Detection, Inrush, and Over-Current Loose Ends

Andy Gardner

Proposed Changes to Baseline Text for Detection and Power-Up

- 104.3.6.5 Turn on time

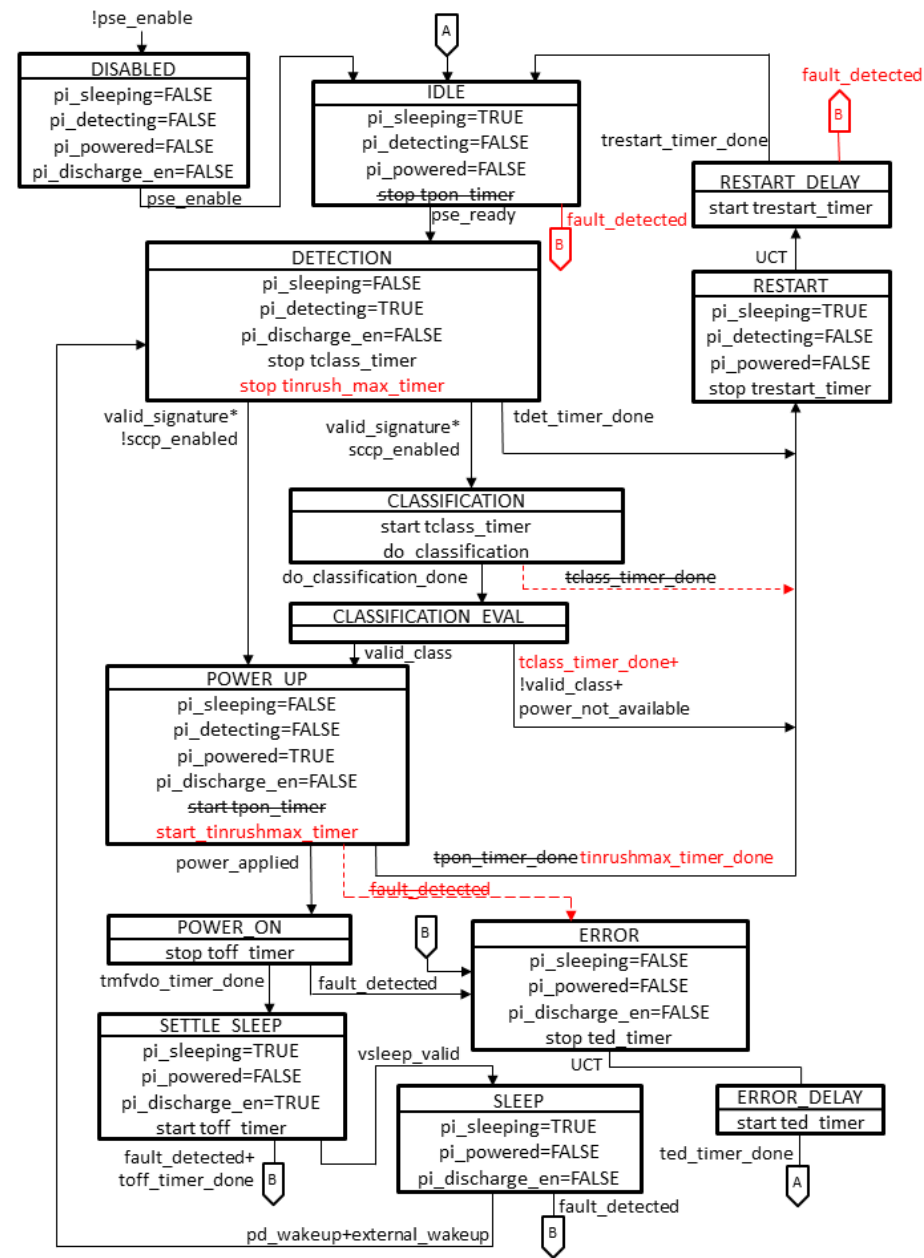
- The specification for T_{inrush} **T_{inrush_max}** in Table 104-3 applies to the **maximum** PSE power up time for a PD after completion of detection. If power is not applied as specified, a new detection cycle shall be initiated before any subsequent application of ~~power~~ **of full operating voltage.**

- 104.4.6.1 PD input voltage

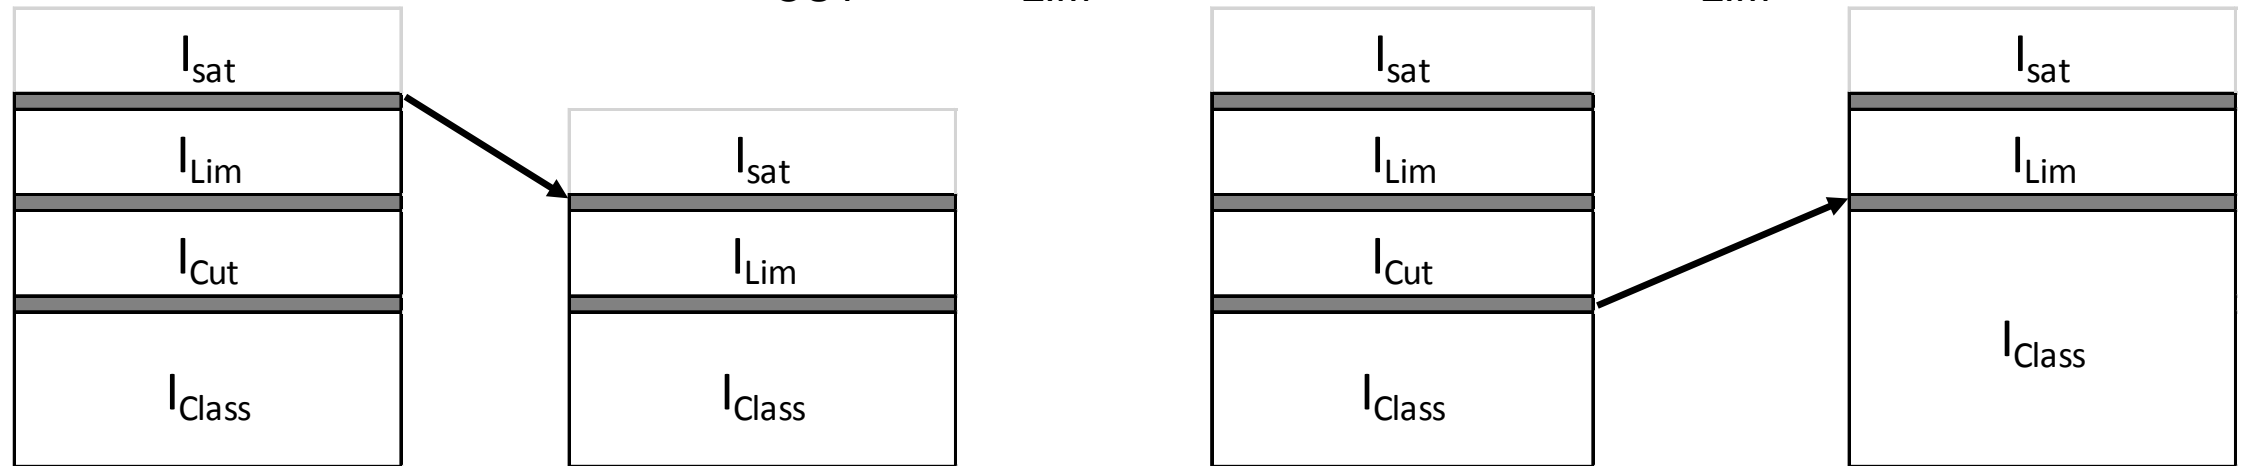
- The PD shall turn on at a voltage less than or equal to V_{On} after a delay in the range of t_{power_dly} as specified in Table 104–6. The PD shall turn off at a voltage greater than or equal to V_{Off} .
- The PD shall turn on or off without startup oscillation and within the first trial for any valid load value when fed by $V_{Port_PSE\ min}$ to $V_{Port_PSE\ max}$ (as defined in Table 104-1) with a series resistance within the range of valid channel resistance.
